Proposed Technical Specification Change

Watts Bar Nuclear Plant Unit 1

Docket No. 50-390

Spent Fuel Pool Modifications  
for Increased Storage Capacity

FIGURE 4.3-1  
SPENT FUEL STORAGE RACKS

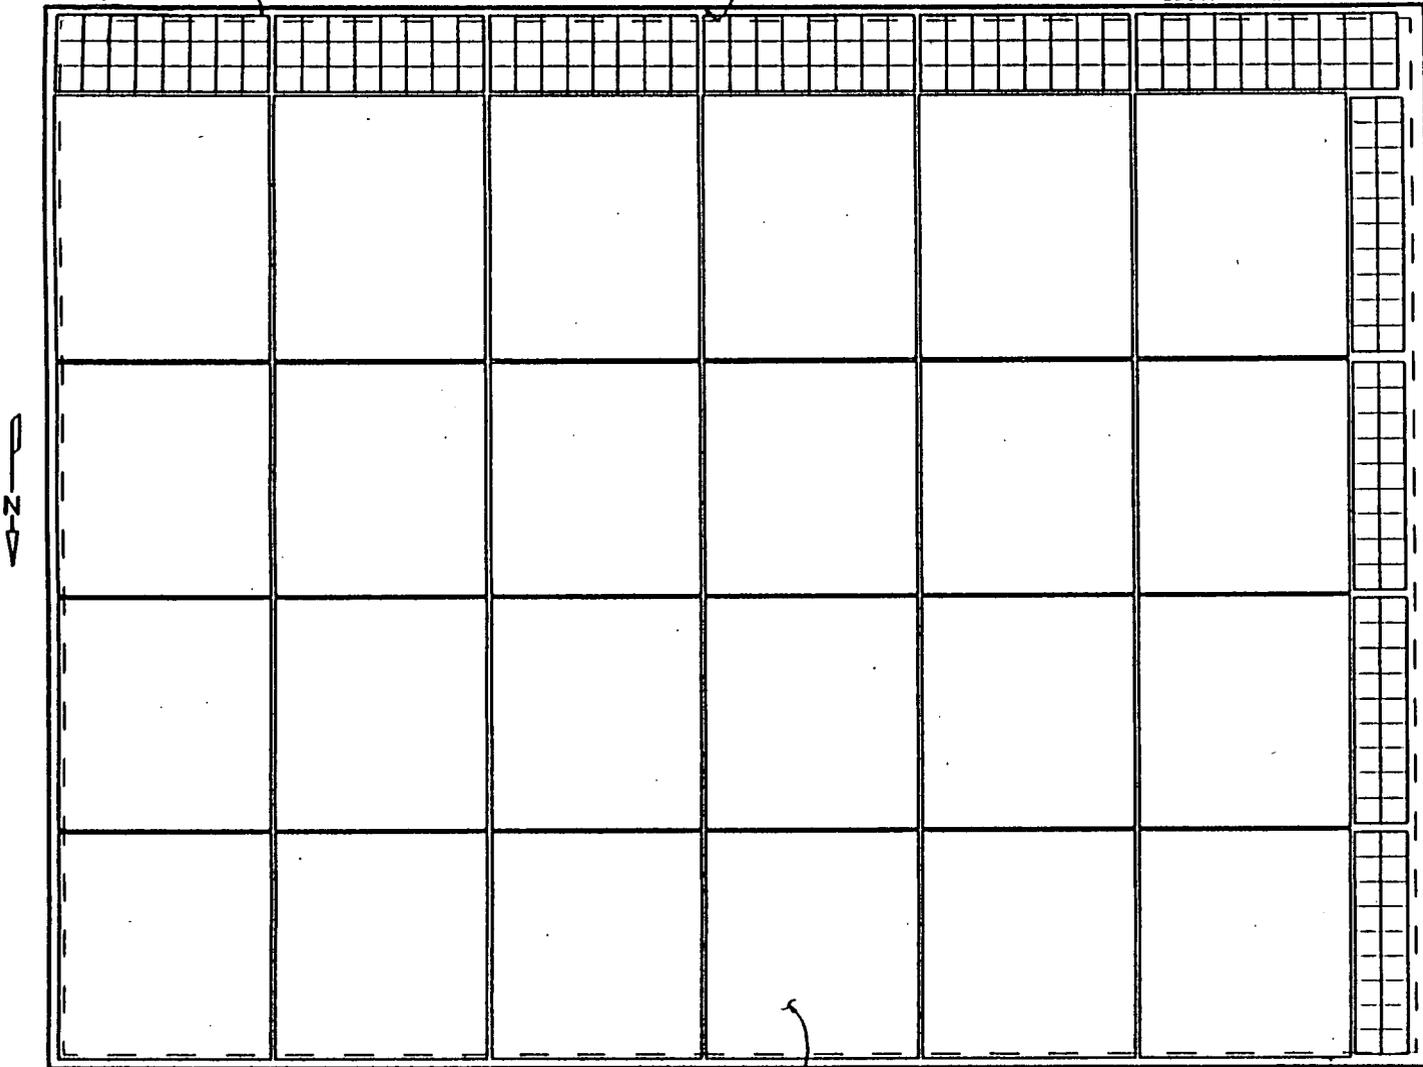
4.3.1.1 The spent fuel storage racks (shown in Figure 4.3-1) are designed and shall be maintained with:

The total spent fuel storage capacity is 1835 fuel assemblies.

- 4.3.3.1 The primary portion of the spent fuel storage pool is designed and shall be maintained with a storage capacity limited to no more than 1386 fuel assemblies in 24 flux trap rack modules.
- 4.3.3.2 No more than 224 fuel assemblies will be stored in ten smaller burnup credit rack modules peripherally located adjacent to the south and west walls of the pool.
- 4.3.3.3 In addition, no more than 225 fuel assemblies will be stored in a single 15 x 15 burnup credit rack module in the cask loading area of the cask pit.

Figure 3.7.15-1 Acceptable Burnup Domain - Watts Bar Spent Fuel Storage Racks

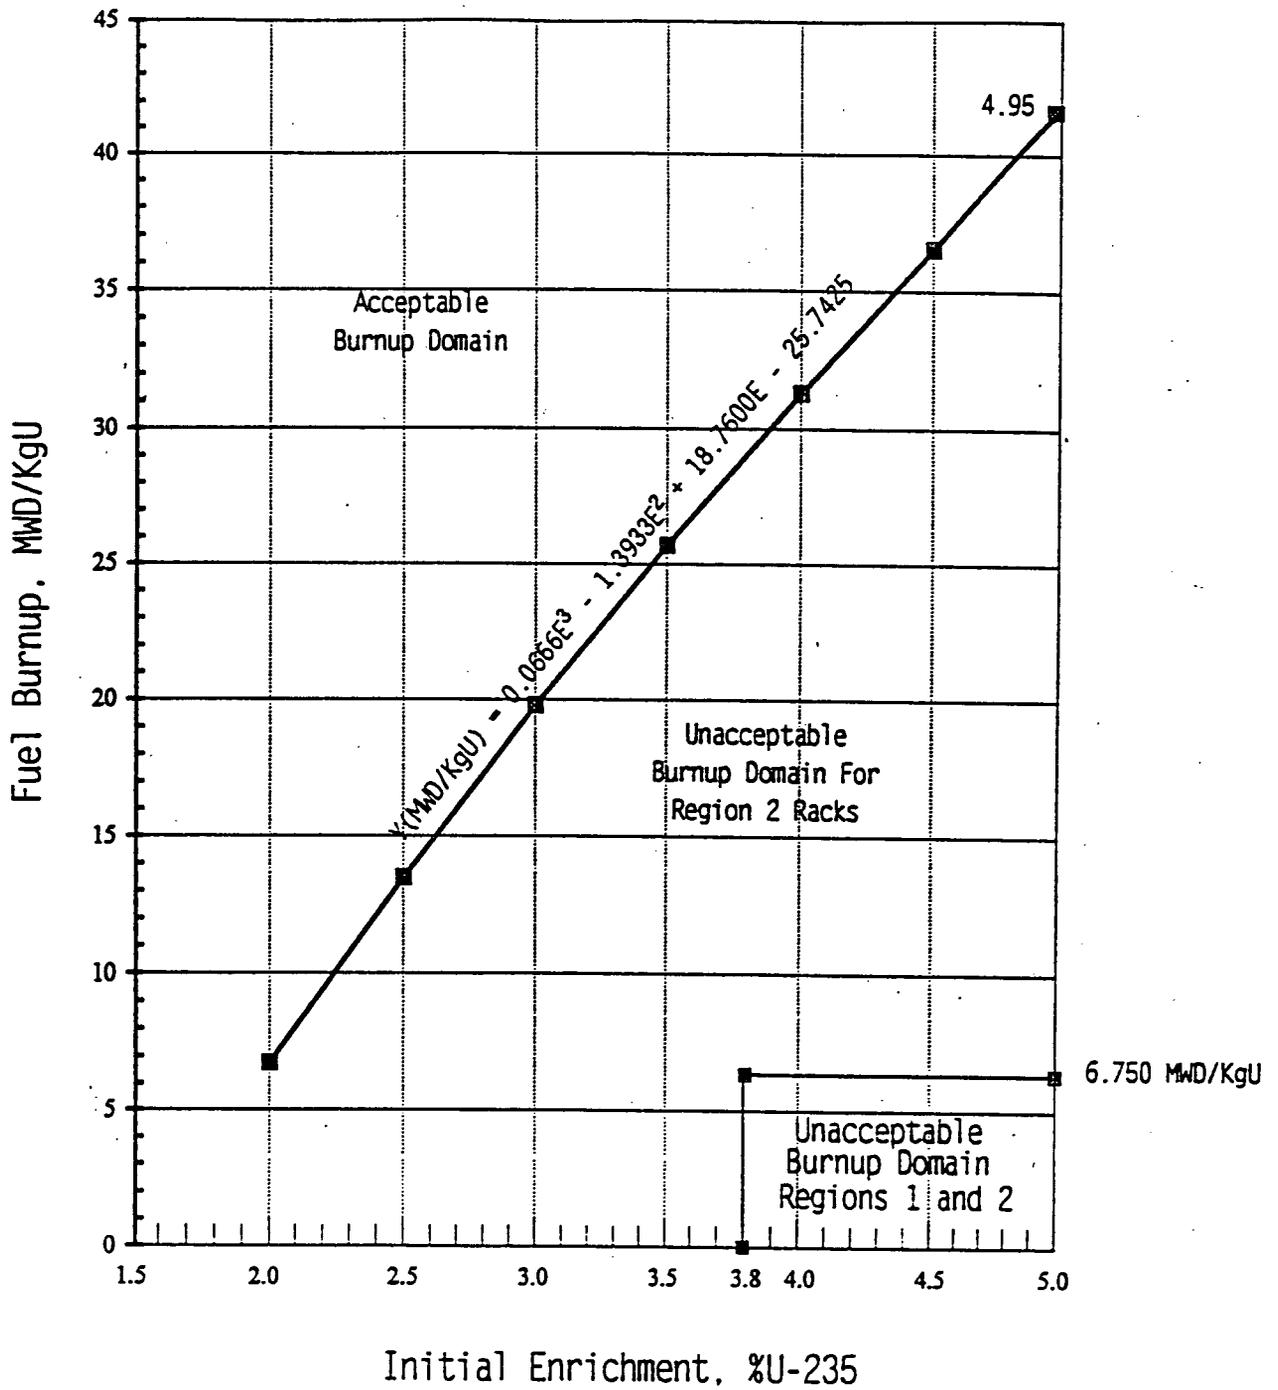
- d. Spent fuel assemblies with a burnup in the "acceptable burnup domain" of Figure 3.7.15-1 may be allowed unrestricted storage in either type of fuel storage rack.

- e. New or partially spent fuel assemblies with a burnup in the "unacceptable burnup domain" of Figure 3.7.15-1 will be stored in compliance with the following configuration:

2. Storage in any burnup credit rack modules (Region 2) located in the pool as well as in the fuel cask loading area is restricted to fuel of  $4.95 \pm 0.05$  weight percent initial enrichment burned to at least 41 MWD/KgU (assembly average), or fuel of other enrichments with a burnup yielding an equivalent reactivity in the fuel racks. The minimum required assembly average burnup is given by  $Y(\text{MWD/KgU})$  where  $Y = 0.0666E^3 - 1.3933E^2 + 18.7600E - 25.7425$ , where  $E$  is the initial enrichment in the axial zone of highest enrichment. Figure 3.7.15-1 illustrates the burnup enrichment equation in graphical form.

LCO 3.7.15 The combination of initial enrichment and burnup of each spent fuel assembly stored in Region 1 or Region 2 shall be within the Acceptable Burnup Domain of Figure 3.7.15-1 or in accordance with Specification 4.3.1.1.

FIGURE 3.9-1 Relationship Between Load, Allowable Height and Impact Area for Dropped Object

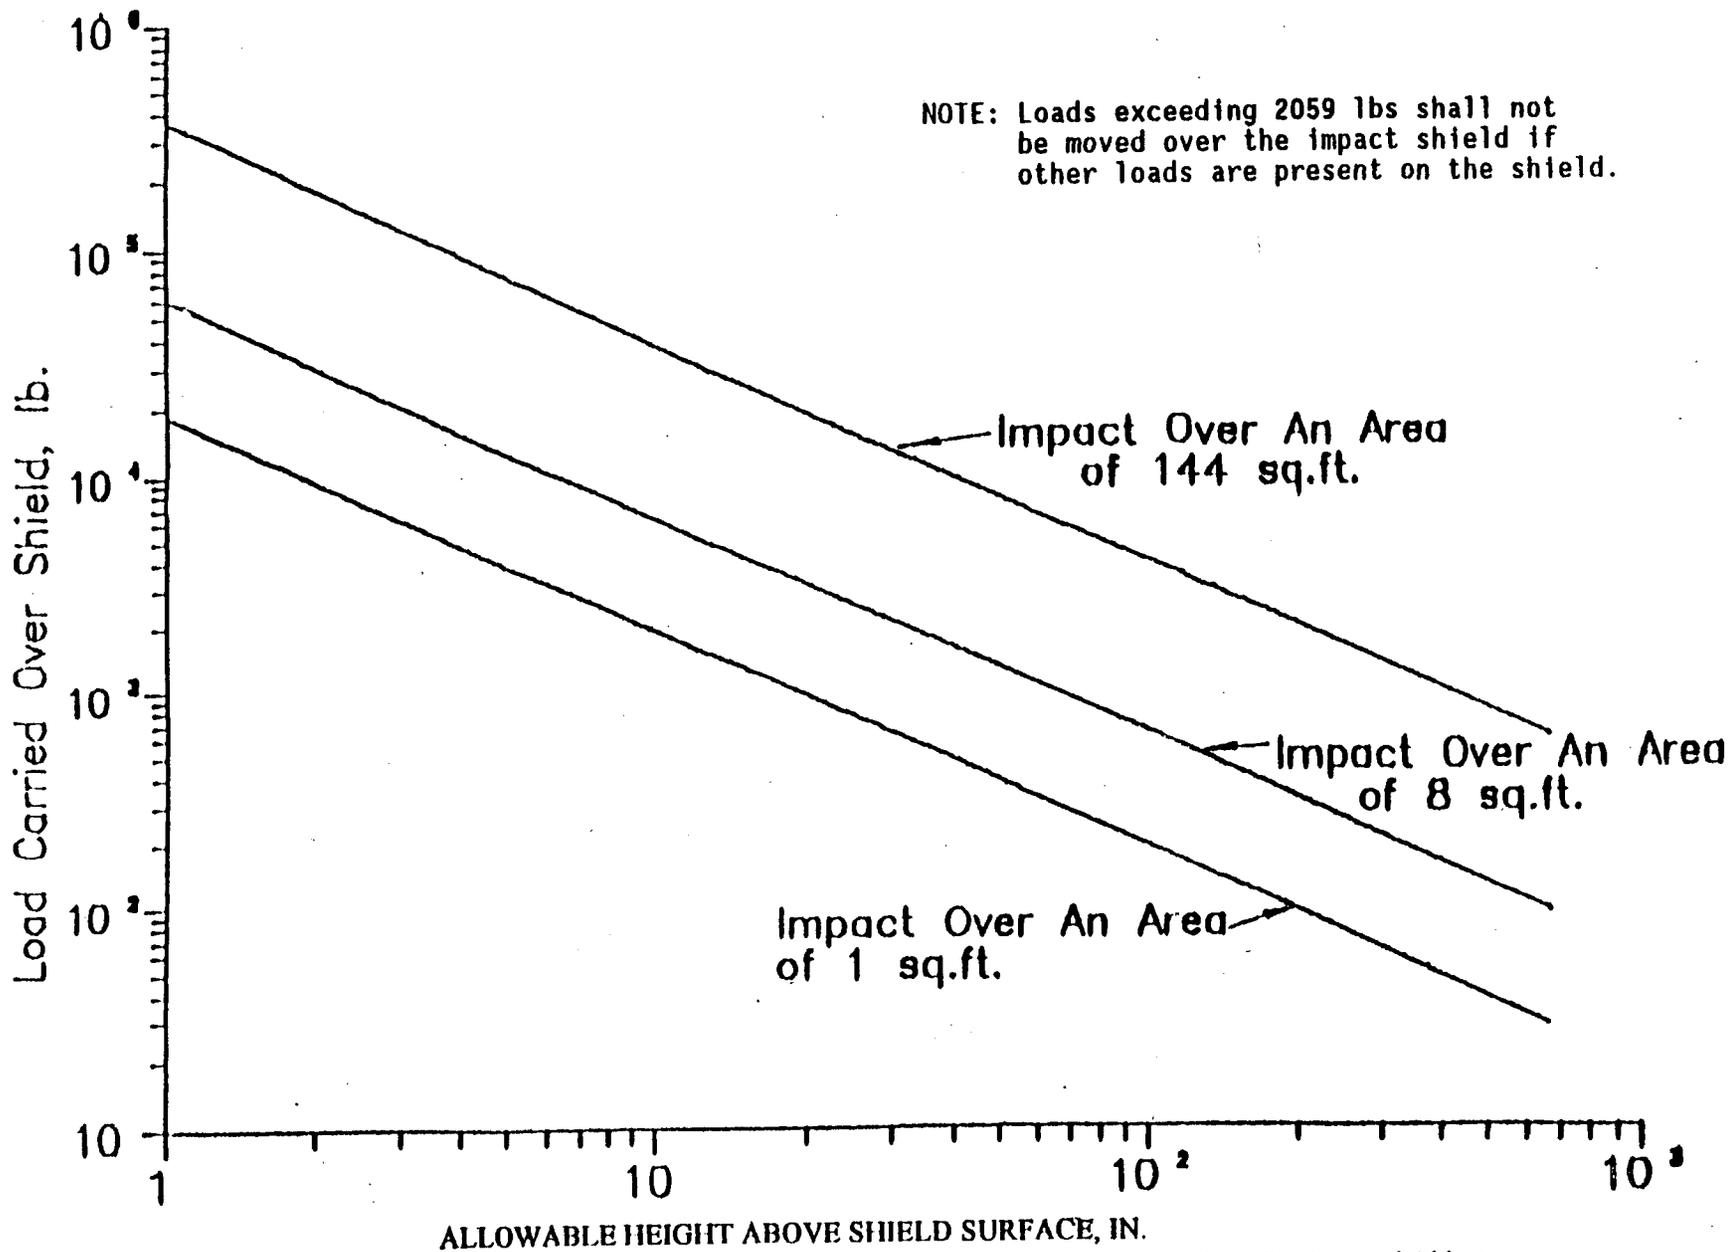
- 1. Loads which meet the weight, cross-sectional impact area, and allowable travel height criteria of Figure 3.9-1 may be carried over fuel assemblies stored in the cask loading area of the cask pit if the impact shield is in place over the cask loading area.
- 2. Loads which do not meet the weight, cross-sectional impact area, and allowable travel height criteria of Figure 3.9-1 shall be prohibited from travel over the cask loading area of the cask pit when fuel is stored in this area.

TSR 3.9.4.2 requires prior verification that the impact shield is properly in place and that each load exceeding 2059 lbs carried over fuel in the cask loading area of the cask pit meet the weight, cross-sectional impact area, and allowable travel height criteria shown in Figure 3.9-1.

FIGURE 4.3-1  
SPENT FUEL STORAGE RACKS

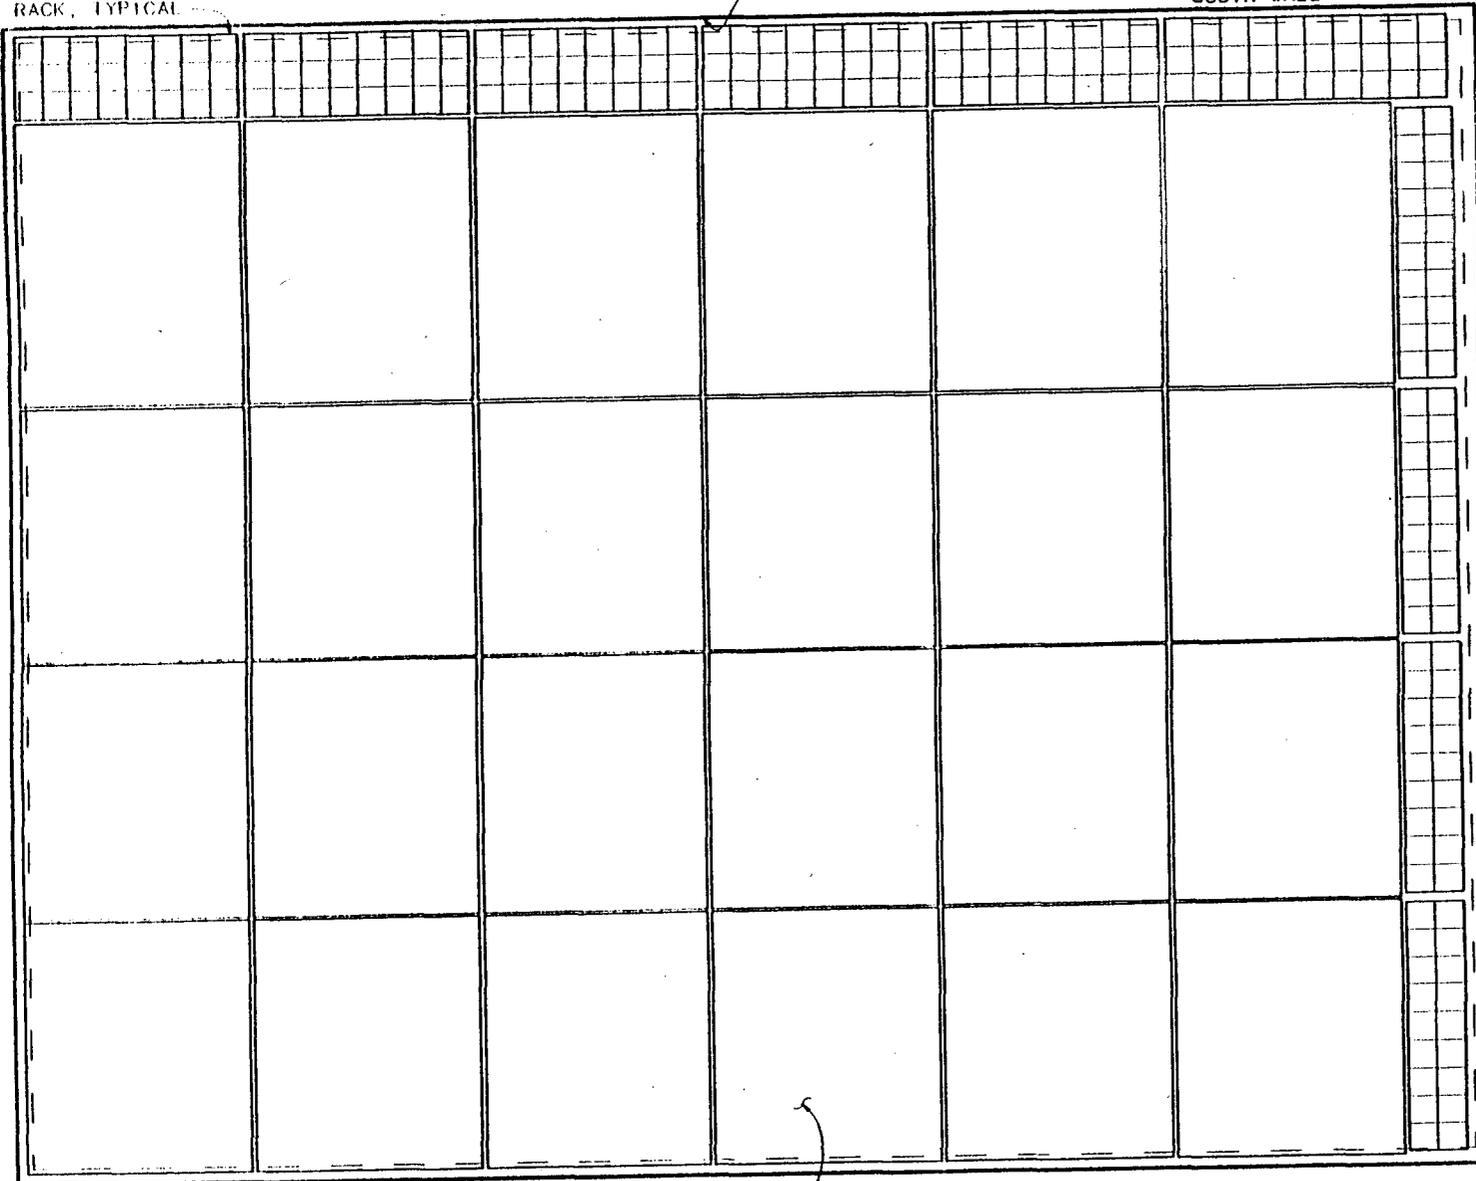
INSERT Above

→ 4.3.3.1 The primary portion of the spent fuel storage pool is designed and shall be maintained with a storage capacity limited to no more than 1386 fuel assemblies in twenty-four flux trap rack modules.

4.3.3.2 No more than 224 fuel assemblies will be stored in ten smaller burnup credit rack modules peripherally located adjacent to the south and west walls of the pool.

4.3.3.3 In addition, no more than 225 fuel assemblies will be stored in a single 15 x 15 burnup credit rack module in the cask loading area of the cask pit.

ADD

15  
 Figure 3.7.17-1 (page 1 of 1)  
 Fuel Assembly Burnup Limits in Region 2

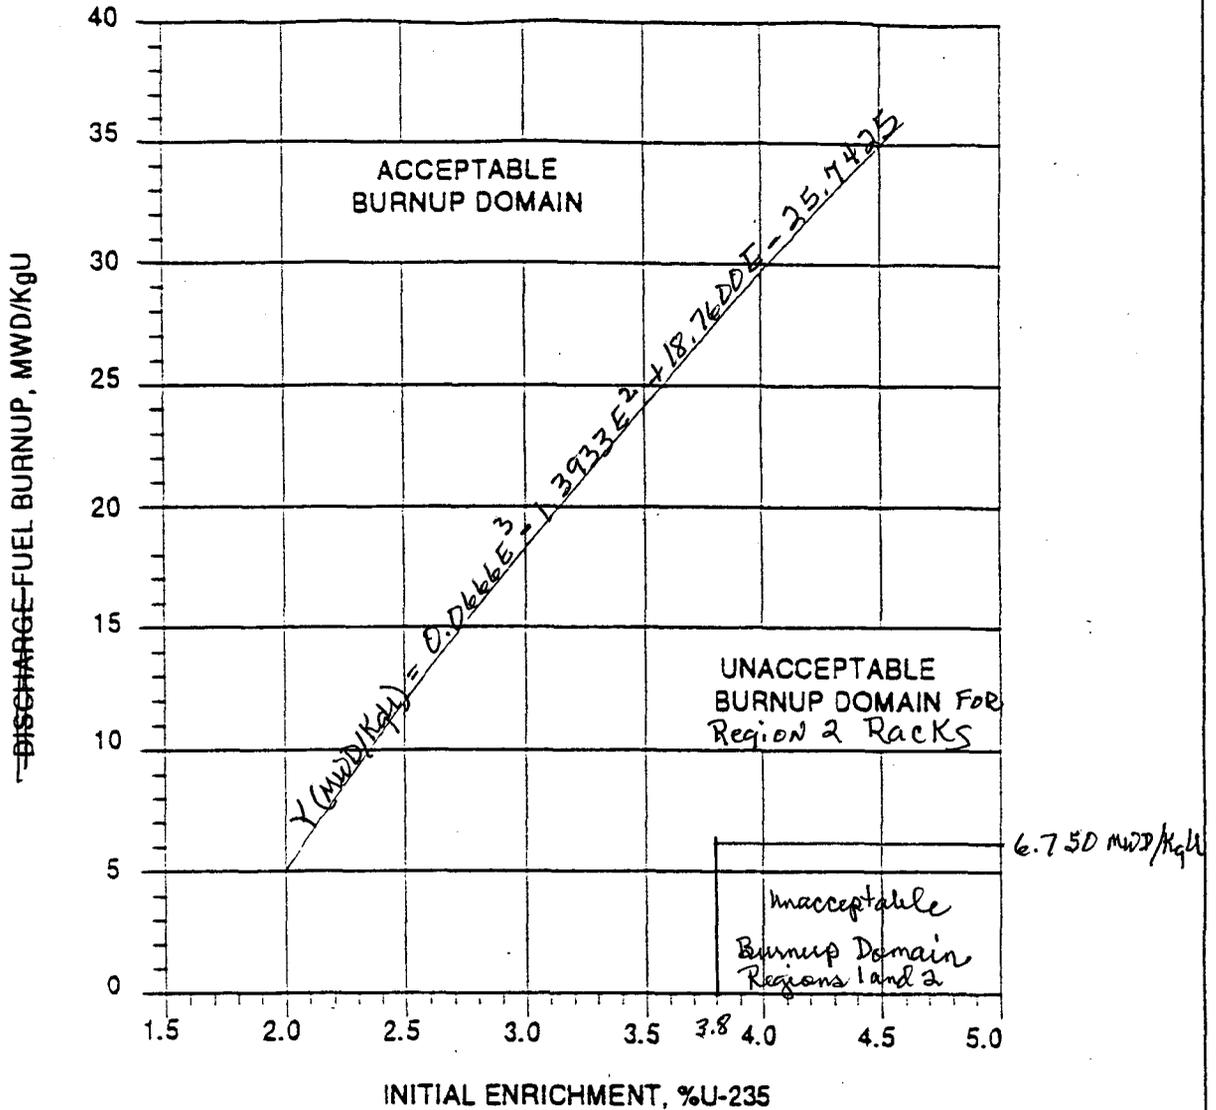
LCO 3.7.17<sup>15</sup> The combination of initial enrichment and burnup of each spent fuel assembly stored in ~~[Region 2]~~ shall be within the Acceptable ~~{Burnup Domain}~~ of Figure 3.7.17-1 or in accordance with Specification 4.3.1.1. 15

Add Figure
